IN THE MATTER OF APPLICATION
FOR PERMIT NO. 63-32573 IN THE
NAME OF M3 EAGLE LLC

**ORDER SCHEDULING
EXCHANGE OF INFORMATION**

M3 Eagle, LLC (M3) is planning to construct a 7,153 unit planned community development on property the company owns in North Ada County. M3 has contracted with HydroLogic, Inc. (HLI), a Boise-based hydrogeologic consulting firm, to conduct an investigation of the area in order to determine the potential for developing a ground-water supply to support the planned community. According to HLI, all of the major municipal supply wells and many irrigation wells within the greater Eagle-Star-M3 area derive their water from the target, regional aquifer. M3 proposes to further develop the aquifer by installing up to fifteen water supply wells within the southwest portion of the property. M3 is seeking a water right with a maximum diversion rate of 23.18 ft³/sec (cfs).

Figure 2. Mapped faults on and near the M3 property (Reproduced from Wood, 2007).

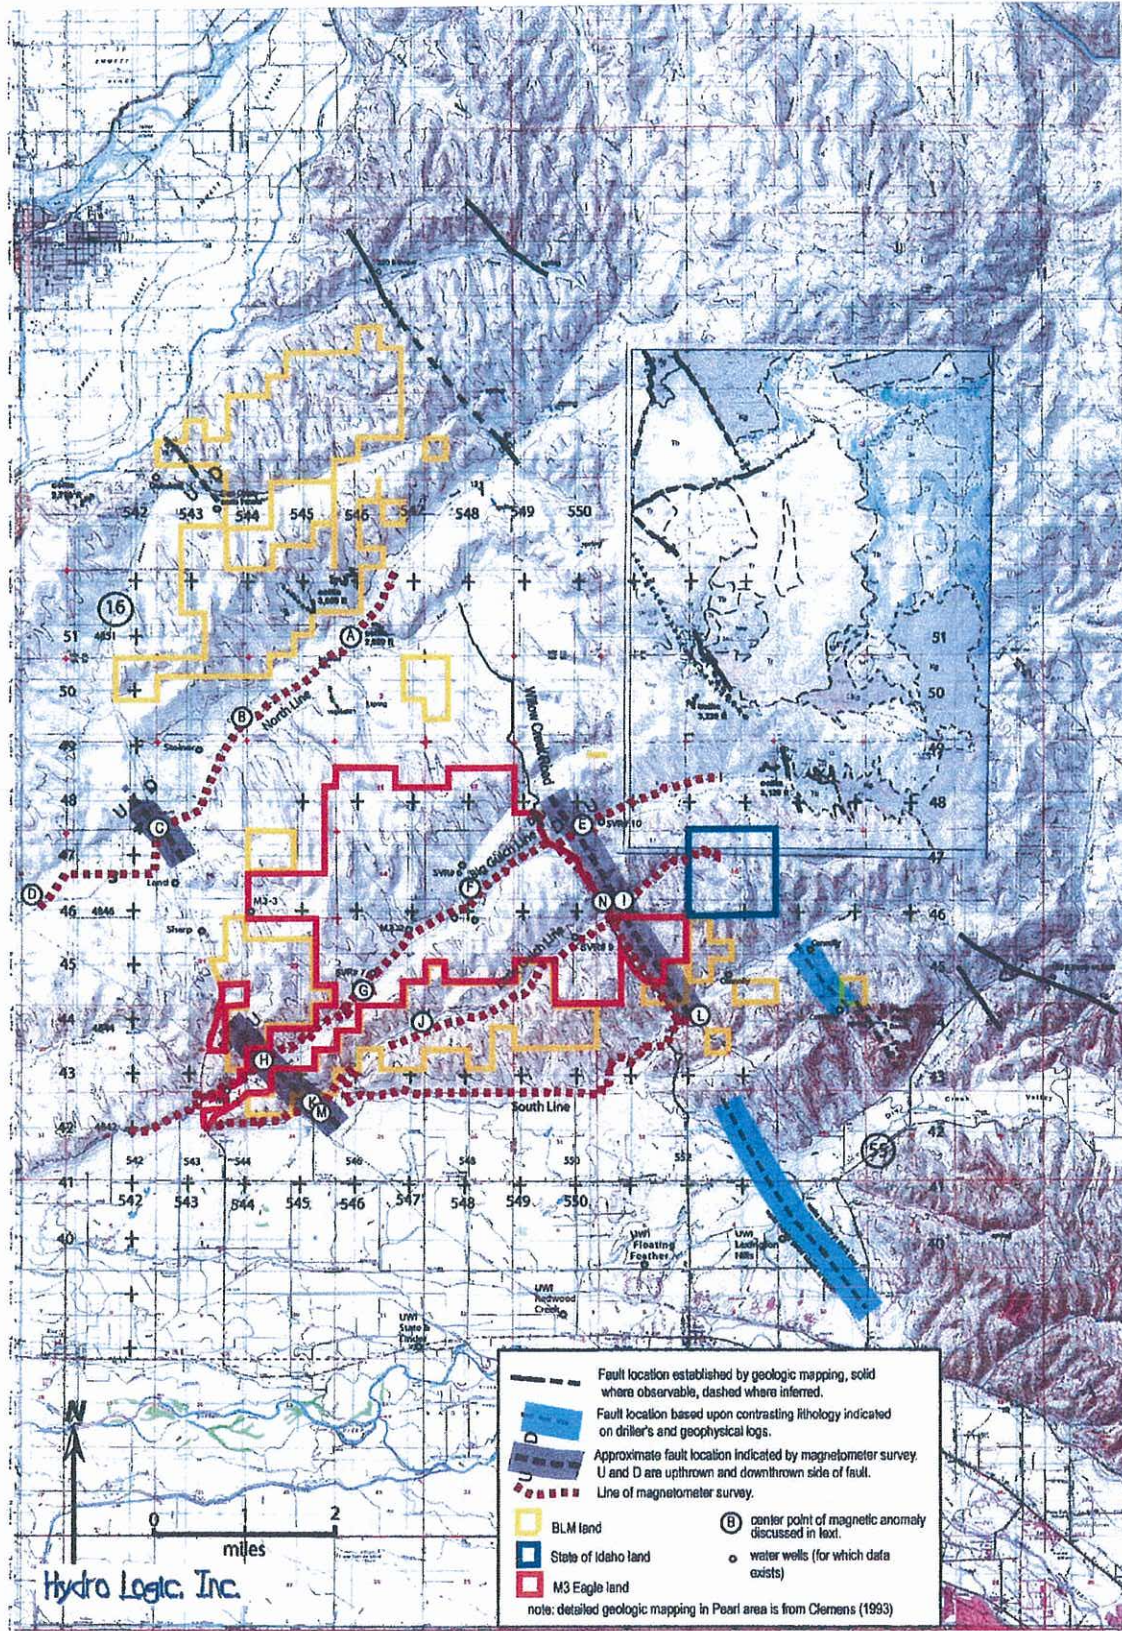
- The cross-section that bisects Big Gulch does not show the fault between TW#1 and TW#4 that was identified in surface geophysical work contracted by HLI (Wood, 2007). The offset from this fault could account for, at least in part, some of the differences in elevation of the tops and bottoms of the various strata that are represented as uninterrupted. The identification of faults is important for the characterization of the hydrogeology because faults often affect hydraulic communication between hydrostratigraphic units.

- The stratigraphic and geophysical logs for TW#4 do not show a strong correlation with the depiction of the mudstone unit drawn in the cross-section that runs from TW#3 to the UWID State and Linder well.

Figure 3. Predicted drawdowns using image well analysis after 50 years of pumping at 10 cfs from the PGSA beneath M3 property.

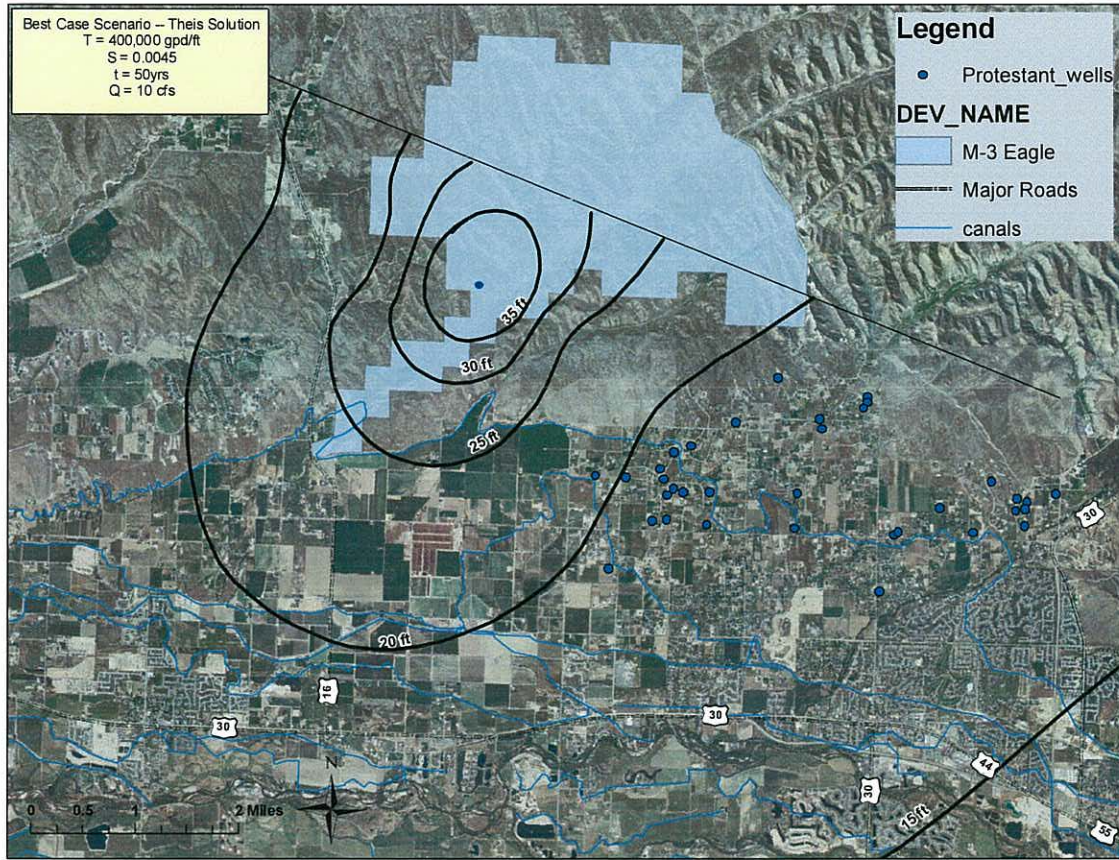
Approximately two miles south of the M3 property, at the intersection of Floating Feather Road and Highway 16, the image well analysis predicted drawdowns of approximately four feet for the best case and eight feet for the worst case (see Figures 9 and 10 in HLI, 2007a). Using the same general methodology but substituting aquifer properties from HLI’s SVR#7 aquifer test (transmissivity = 400,000 gpd/ft, storage = 0.0045), IDWR staff calculated drawdown for a revised pumping rate of 4,500 gpm and a pumping period of 50-years (the same time-frame evaluated with the M3 model). Our calculation is conservative in the sense that it neglects to consider recharge but not-conservative because it assumes that the aquifer extends infinitely in the southwest (down-dip) direction. The predicted drawdown at the intersection of Floating Feather Road and Highway 16 is approximately 18 feet after 50 years of pumping (Figure 3).

It is common practice to predict long-term aquifer performance using time-frames that are less than 50 years when applying analytical methods which are based on the Theis (1935) nonequilibrium solution. The Idaho Department of Environmental Quality, for example, recommends that a one-year time-frame be used to project long-term drawdown for public water supply wells. The use of a shorter time-frame can be appropriate, in part because the Theis (1935) solution is premised on the assumption that there are no sources of recharge. With all other input unchanged, application of the image well analysis using a pumping period of one year instead of 50 years results in a similar water level drawdown pattern but the drawdowns are of lower magnitude. The calculated drawdown after one year of pumping at 10 cfs is approximately 8 feet at the intersection of Floating Feather Road and Highway 16.

Figure 4. Map showing the results of predicted drawdown from the Hmatch version of the M3 ground water flow model (HLI, 2008a, Appendix B, Figure 14).

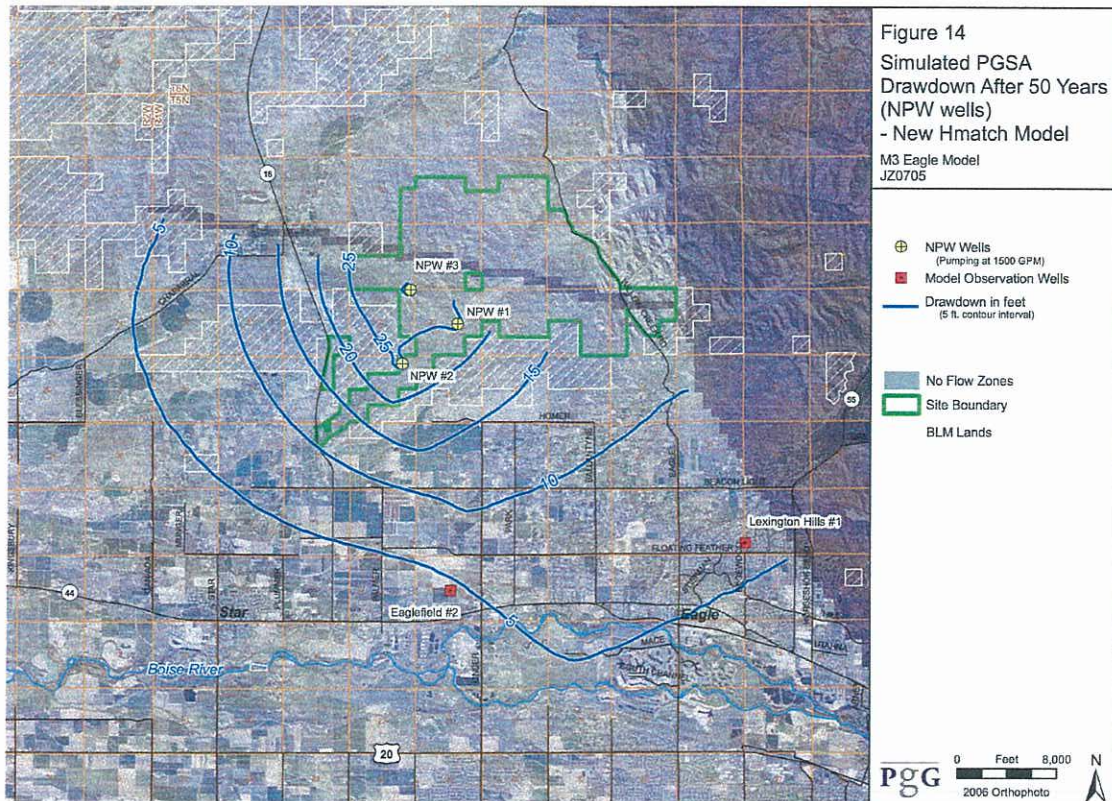
As previously discussed, HLI contracted the development of a ground water flow model that was used to predict impacts from the pumping of high capacity wells on the M3 property. The “Hmatch” version of the model indicates that 50 years of pumping three wells at a combined total rate of 10 cfs will cause drawdown in the PGSA that ranges from approximately 30 feet on the property to around five feet at the intersection of Floating Feather Road and Highway 16 near Eagle (Figure 4).

The NW/SE trending fault identified between TW#4 and TW#1 through magnetometer studies was not included in any of the impact assessments performed by HLI or the Department. Based on HLI’s aquifer test analysis, this fault potentially represents a no-flow boundary, which could significantly alter the predictions by causing more drawdown on the pumping side of the fault and less drawdown on the non-pumping side.

Figure 1.

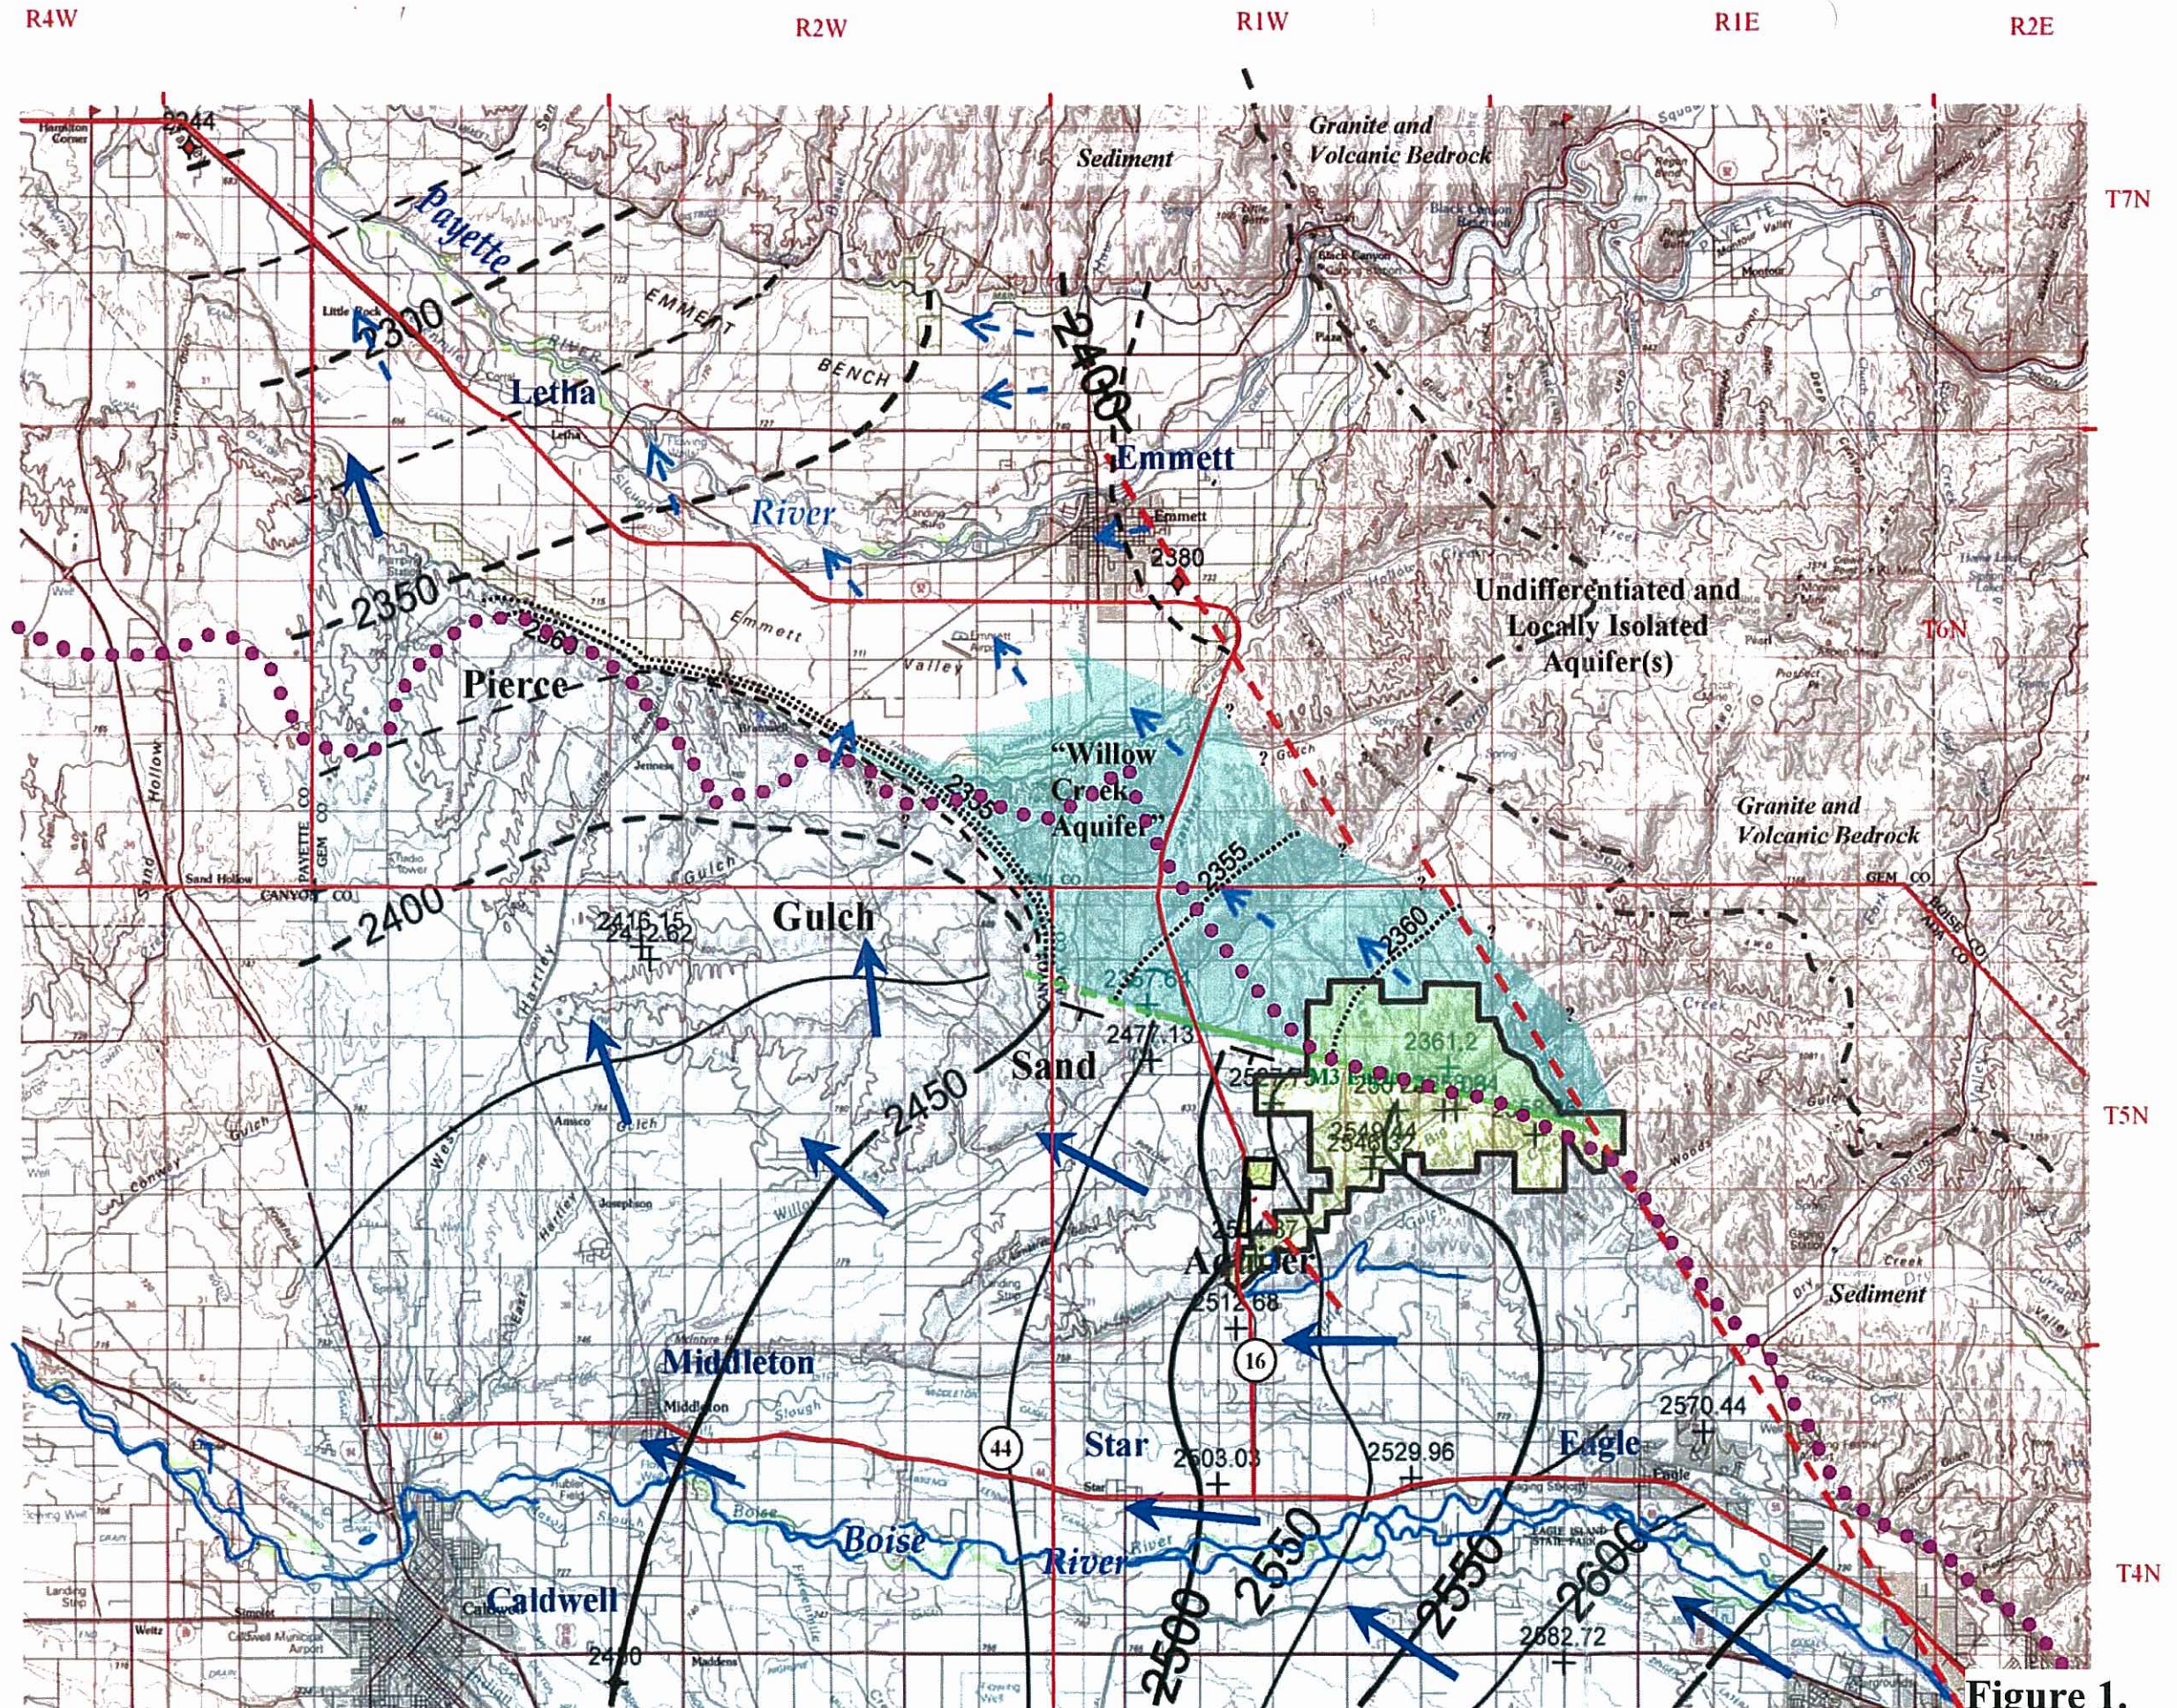
Essentially no hydrogeologic data are presented to support the boundary of the Pierce Gulch Sand Aquifer more than about one mile northwest of the M3 Eagle site, as shown on Figure 4.

This is incorrect. Several of the peer-reviewed publications cited by Dr. Ralston clearly describe the regional extent of the of the prograding delta system that comprises the Pierce Gulch Sand Aquifer.¹ These same reports also provide sub-surface cross-sectional

It is possible that Dr. Ralston did not recognize that the reports cited by Hydro Logic (and cited by Dr. Ralston's own reports)³ show the geologic extent of the Pierce Gulch Sand Aquifer and that M3 Eagle, LLC's submittal on November 26, 2008 included the data from these wells (at Tab 19 of the binders provided to the Department in November 2008). Although the geophysical log data were available only in copies having very small print and are difficult to read without magnification, the accompanying reports and sub-surface cross-sections make the three-dimensional geometry and extent of the Pierce Gulch Sand abundantly clear. In any event, these data to the west and west-northwest show that the subsurface contains the same Pierce Gulch Sand Aquifer signature, including the geophysical signature of the underlying transgressive sand of the Terteling Springs Formation underlying it, as is present under the western portion of the M3 Eagle property. The PGSA also shows up in these data along the same approximate dip angle as that under the M3Eagle property and elsewhere.

Attached hereto, we provide the following four figures depicting the "no-flow-to-the-Payette" model run:

- 1) A map of the model showing the area converted to no flow in the model based on the TVHP boundary (Gray).
- 2) A map of the entire M3 model area depicting the imposed no flow boundary of the TVHP.
- 3) A figure showing a comparison of the two model boundaries (original M3 model versus TVHP boundary) and the target heads of the model run.
- 4) A figure showing the 50-year predicted long-term drawdown from the M3 ground water withdrawals at full build out.
